From: Kristen Kapelanski, AICP
Date: 10/22/2021
Re: **Bebb Oak Meadows, 2800 Rochester Rd. (City File #21-008)**
Site Plan - Planning Review #4

From: Keith Depp, Project Engineer **KPD**
To: Kristen Kapelanski, AICP, Planning Manager
Date: October 22, 2021
Re: **Bebb Oak Meadows, City File #21-008, Section 27
Site Plan Review #4**

Re: Bebb Oak Meadows Mixed-Use Development
Traffic Impact Study Review #2

Typical 8' Pathway Section

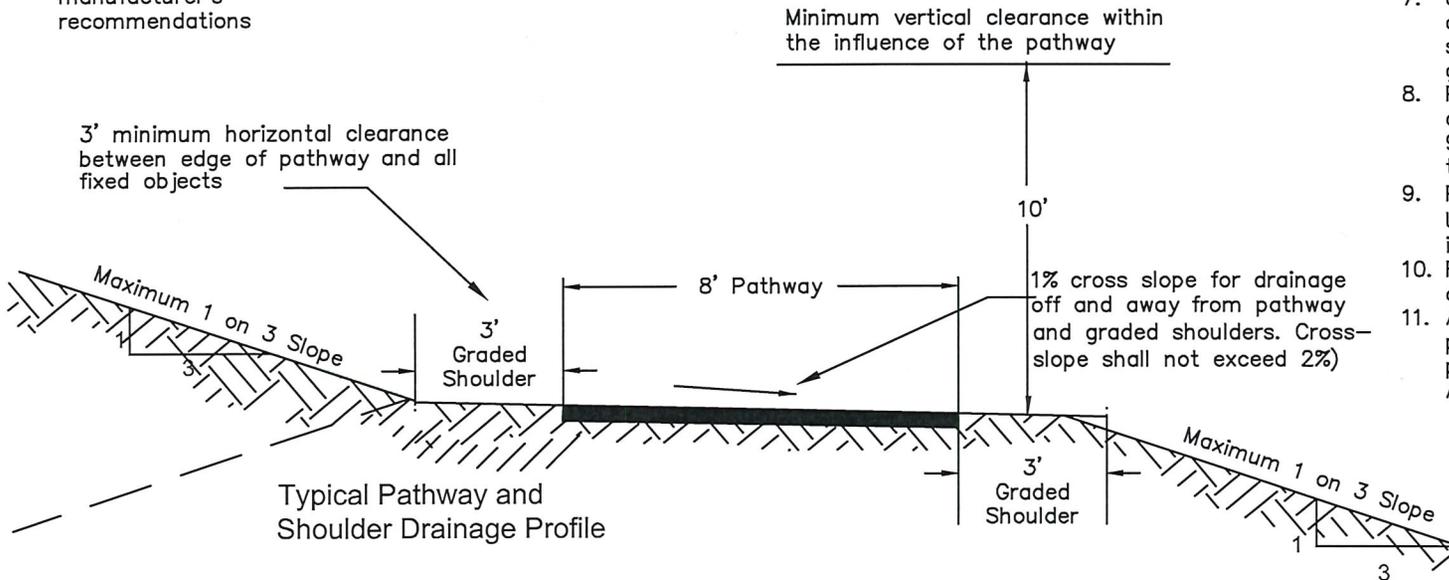
1. Show the City Pathway Construction Detail attached.
2. Add note to Landscape Plan, to the affect, "Irrigation overspray shall not broadcast onto the City Pathway."
3. Show the Driveway locations across the road from the Bebb Oak development, particularly the southerly driveway to the plaza.
4. It is highly encouraged to minimize CAD layers to make the plans less cluttered.

**Table 3-5 Guideline for Unsignalized
 Driveway Spacing**

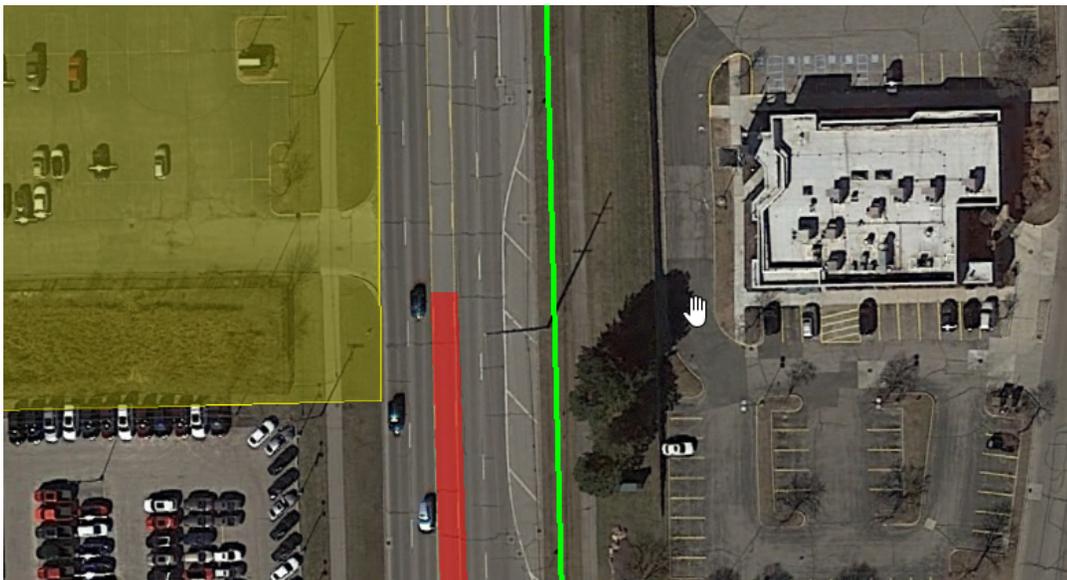
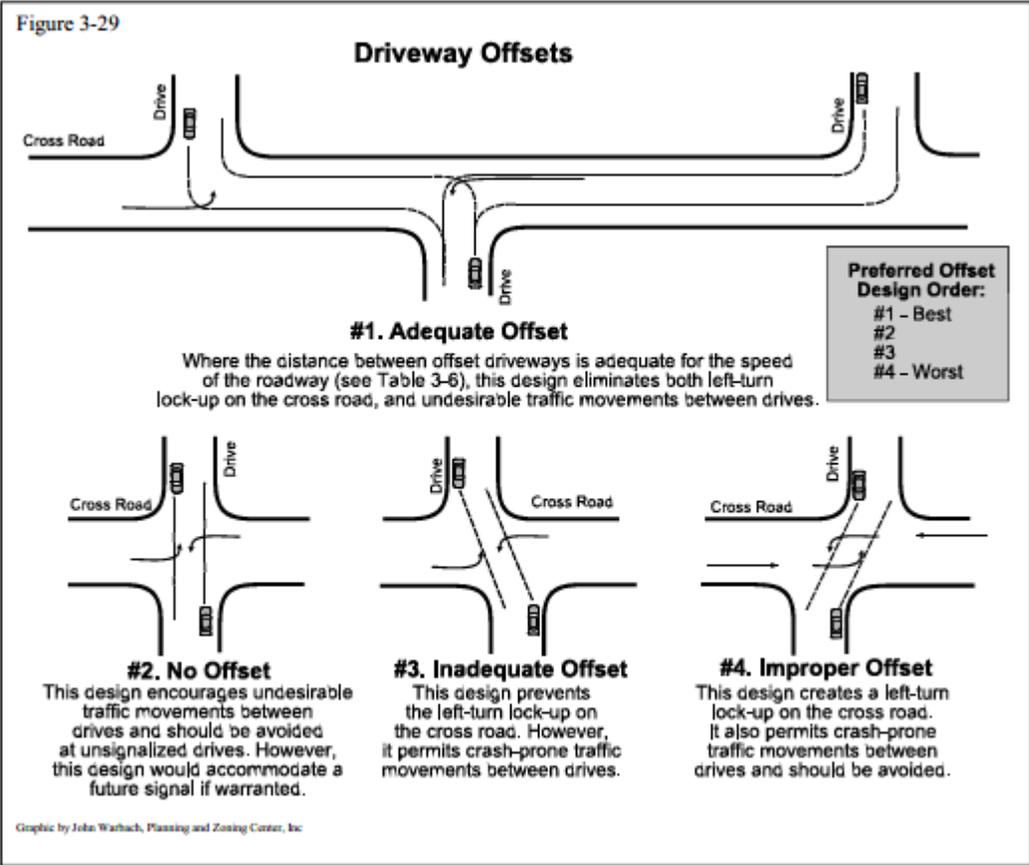
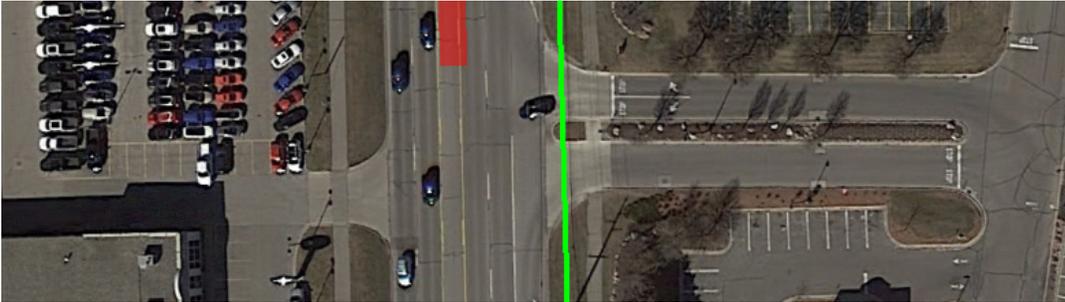
One drive will be allowed based on the MDOT Access Management Guidelines (see below). At 50 MPH, the recommended spacing is 455 ft. The distance between the existing Belle Tire and Huntington Ford Dealership drives is about 550 ft. Splitting the distance with one drive to the site, still provides only 275' between drives. Any other desired access points should come via cross-access agreements or shared drives with the adjacent properties.

The potential for "left-turn lock-up" (#4 below) between the proposed site drive and the southern drive to Hampton Center shall be evaluated and mitigated as necessary.
